**DEVIATION REQUEST
 AND DECISION FORM**

Project Name : Grandwood Ranch
 Schedule No.(s) : 6119000003
 Legal Description : S2N2, EX PT TO HIGBY RD CONV BY REC# 205092691 W/MR SEC 19-11-66

Section 2.5.8.C Design Standards for Roadside Ditches specifying 'Type C Grate Inlets are not permitted in roadside ditch applications'.

GRANDWOOD RANCH			
EL PASO COUNTY			
TYPE C INLET EXHIBIT			
DESIGNED BY: CAP	SCALE: 1"=100'	DATE ISSUED: SEPTEMBER 2020	DRAWING No. EX1
DRAWN BY: CAP	HORIZ: N/A	SHEET: 1 OF 1	
CHECKED BY: JA	VERT: N/A

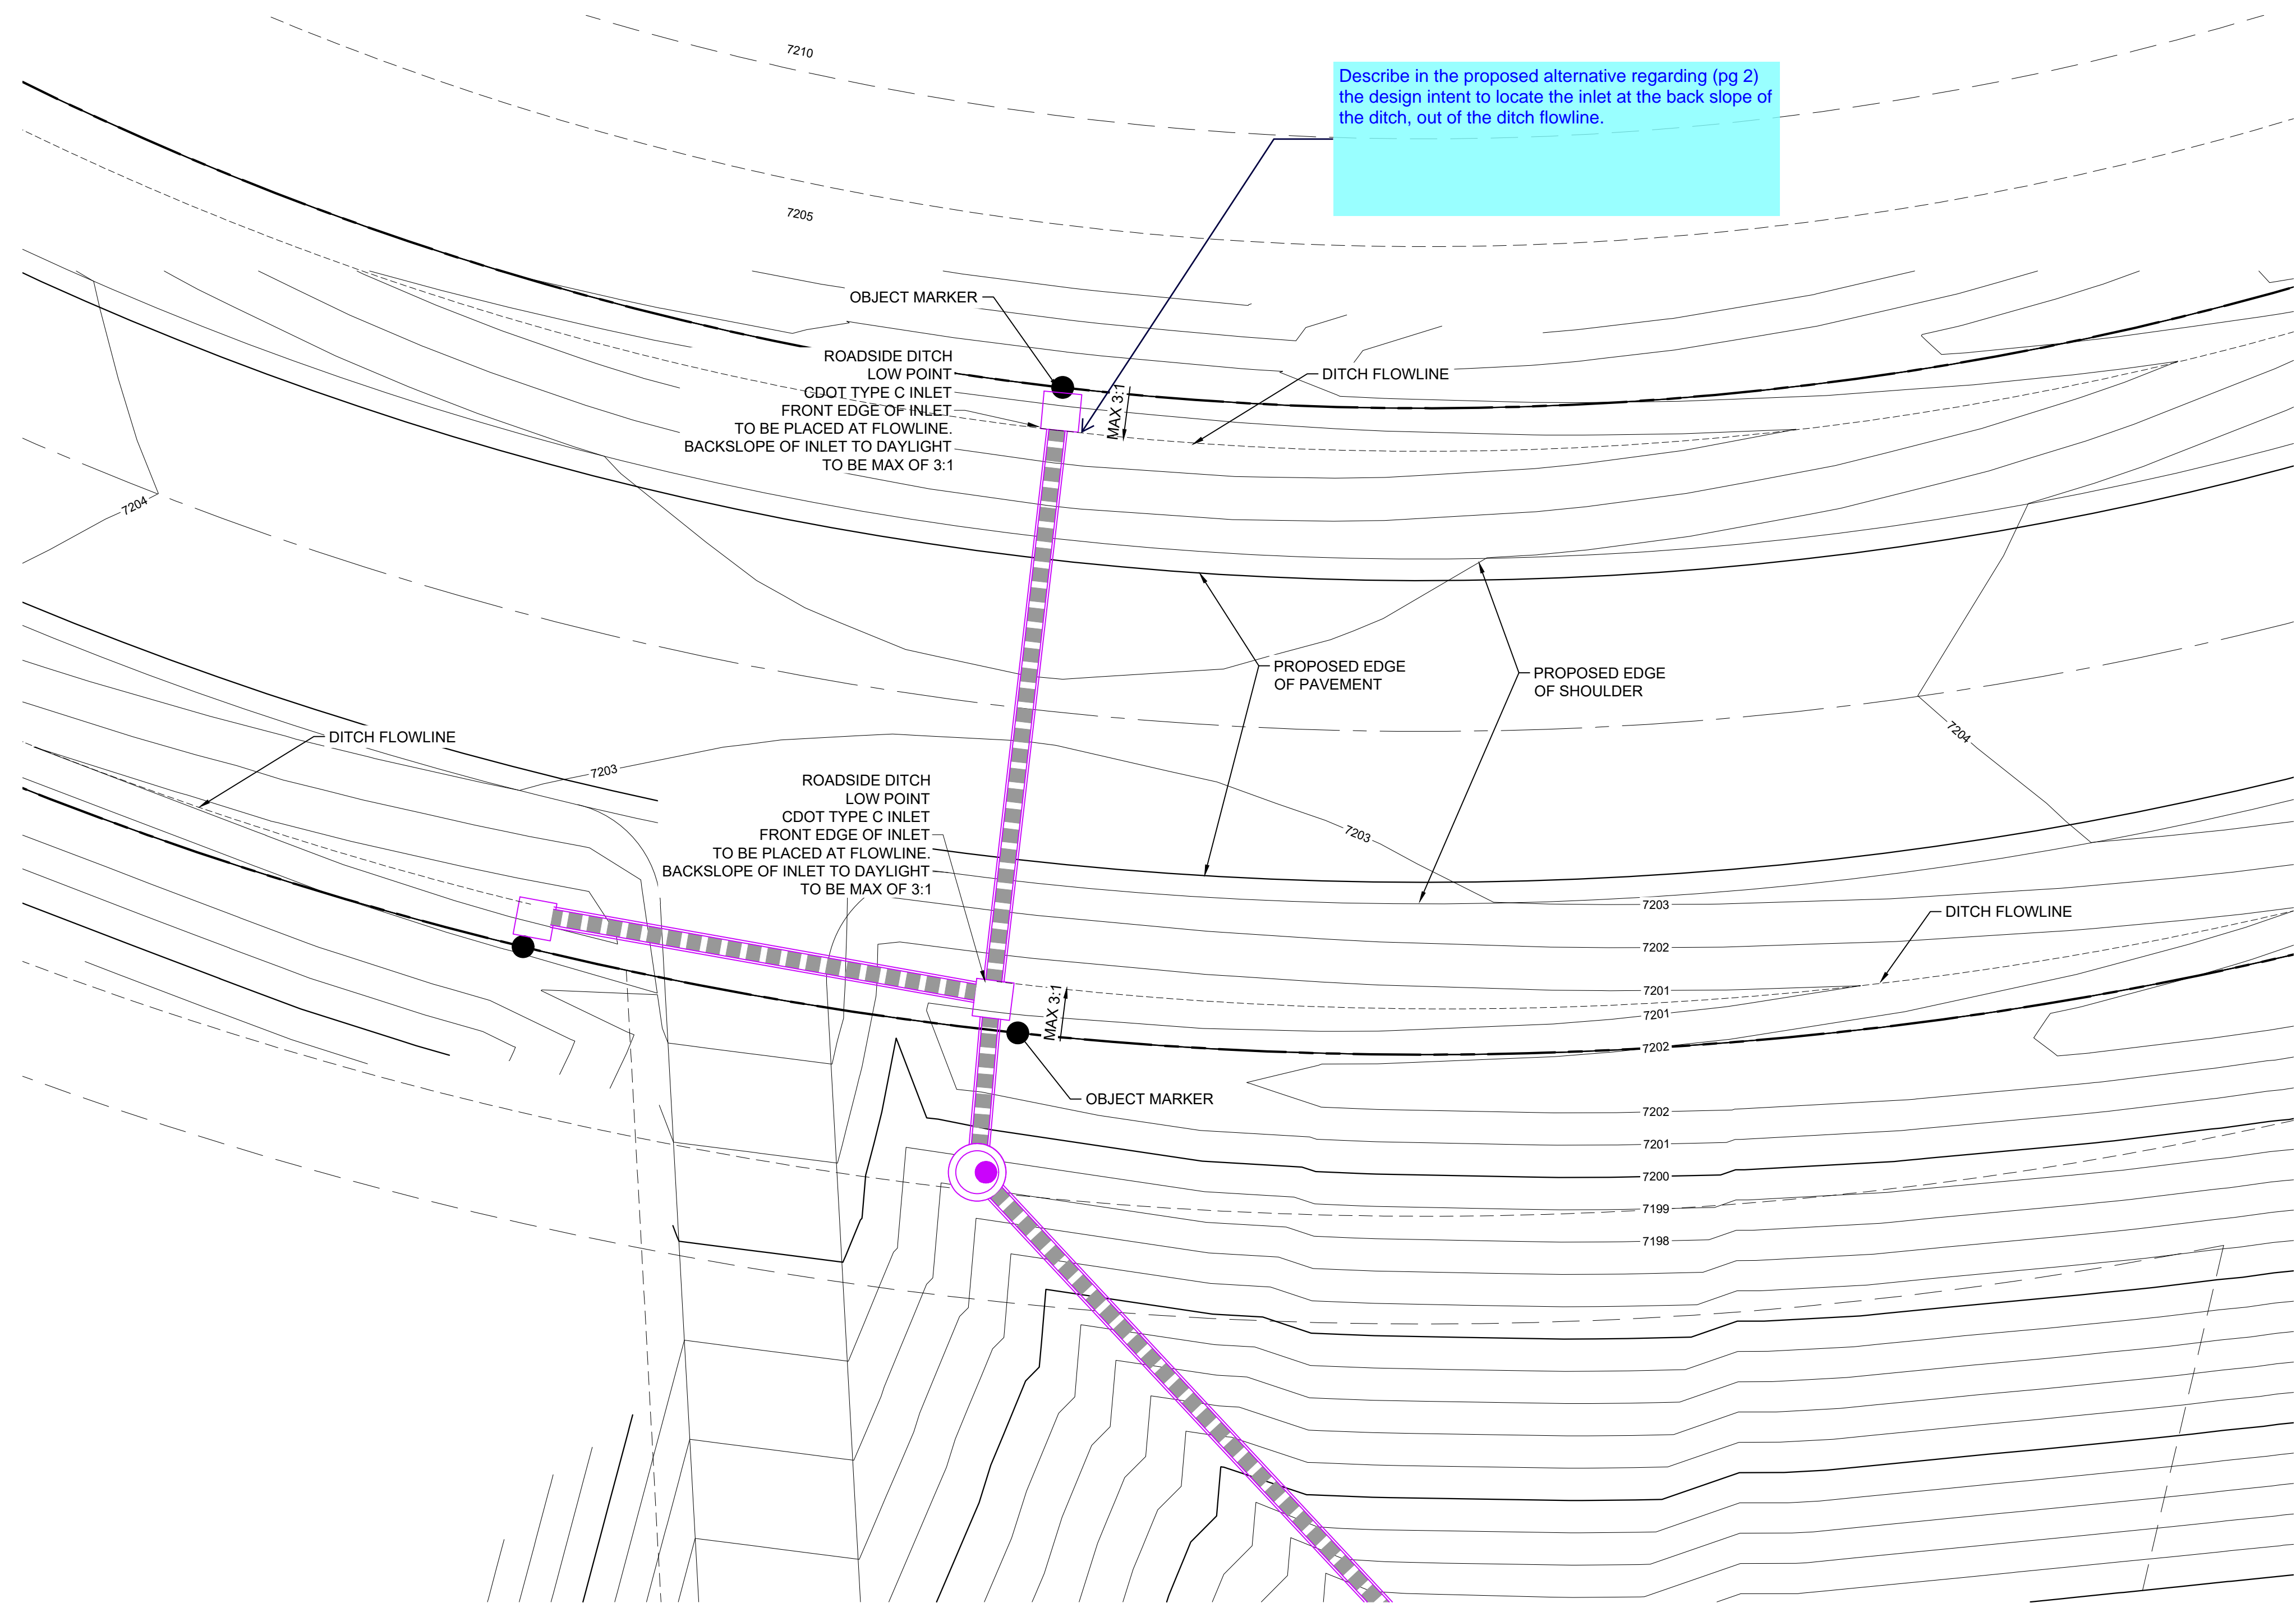
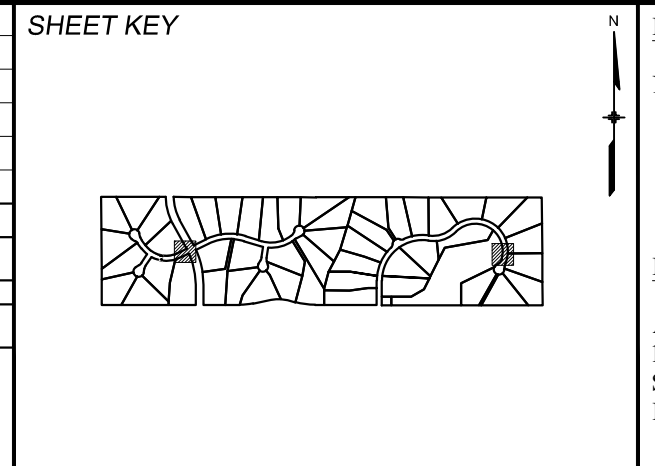
Revise to SF2026

Add to the proposed alternative in page 2. The CDs noted this will be installed at the back of the inlet.

explain locating the inlet to the backslope and not centered on the flowline for maintenance
